Access Compliance Report

Public Rights-of-Way

Intersection ID: 50401	Main Street: DEBORAH_DR	Cross Street: WILSON_DR	Location: S
ADA ID: 7810A19FEAB5	Ramp Type: Perp	Initial Pass/Fail: Fail	Overall Compliance: No
Severity Score: 1.25			
Codes/Mitigation Info/Possible Solution		Field Measurements/Component Compliance

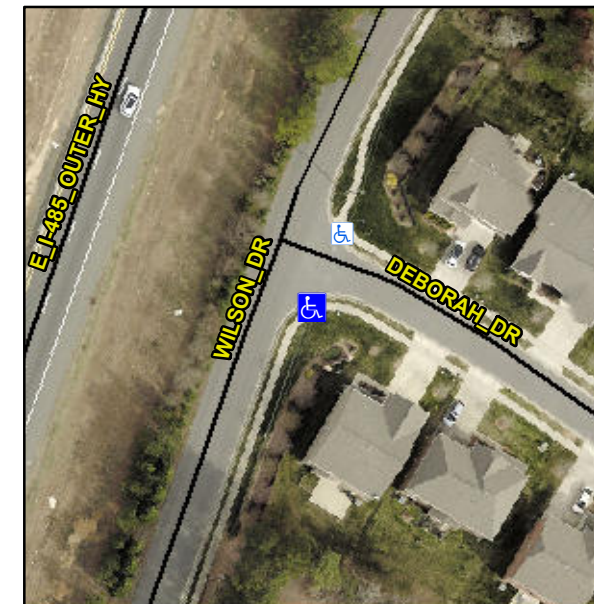
Not Found, R304.5.3

Compliance	Description	Data	Compliance	Description	Data
N/A	Ramp Length (in)	78.0	Yes	Ramp Slope (%)	7.9
Yes	Ramp Width (in)	48.0	No	Ramp XSlope (%)	2.9
N/A	Flare Type LT	N/A	N/A	Flare Type RT	N/A
N/A	Flare Slope LT (%)	N/A	N/A	Flare Slope RT (%)	N/A
N/A	Flare Traversable LT?	N/A	N/A	Flare Traversable RT?	N/A
N/A	Landing Length (in)	N/A	N/A	DWS Provided?	N/A
N/A	Landing Width (in)	N/A	N/A	DWS Contrast?	N/A
N/A	Landing Slope (%)	N/A	N/A	DWS Length (in)	N/A
N/A	Landing X Slope (%)	N/A	N/A	DWS Full Width?	N/A
N/A	Landing Curb? (Y/N)	N/A	N/A	DWS Offset (in)	N/A
N/A	Shared Landing?	N/A			
N/A	Gutter Ponding?	N/A	N/A	Gutter Slope (%)	N/A
N/A	Gutter Lip Ht (in)	N/A	N/A	Gutter X Slope (%)	N/A
N/A	Painted X Walk1?	No	N/A	Painted X Walk2?	N/A
	X Walk 1 Direction	To NE		X Walk 2 Direction	N/A
N/A	X Walk 1 Width (in)	N/A	N/A	X Walk 2 Width (in)	N/A
	X Walk 1 Slope (%)	0.0		X Walk 2 Slope (%)	N/A
	X Walk 1 X Slope (%)	1.7		X Walk 2 X Slope (%)	N/A

Remove & Replace Entire Ramp.
